**FIELD SERVICE BULLETIN**

FSB Number: LVCCFSB2006-164  
Author: Tony Bryan  
Date: April 24, 2006  
Total No. of Pages: 2  
Subject: GSM PEBL U6 – Board-to-Board Connector  
Model Affected: GSM PEBL U6  
Level of Repair: 2

Figure: 1.0

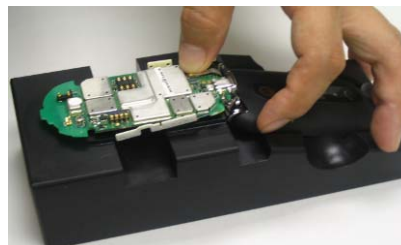
Service has been made aware of an issue identified during NPI analysis of GSM PEBL U6 phones. Some units, returned with customer complaints including “Display Main – No Display” and “Audio – Earpiece, No”, were found to be caused by a poor connection between the Hinge Flex’s 40-pin connector and the J1300 PCBA connector as shown in Figure 1.0 below. Analysis revealed, this issue is caused due to assembly process. If the connector is not fully seated initially, this may result in an intermittent or latent failure.

Hinge Flex 40-Pin Connector  
to J1300 PCBA Connector  
location

The factory implemented an assembly fixture to assist operators and modified the Assembly SOP to stress connector properly seated. – 02/25/2006

- 1) Make sure to put PCBA flatly on the assembly fixture.
- 2) Press the flip connector twice with thumb to ensure the connector fully engage into the connector on PCBA.
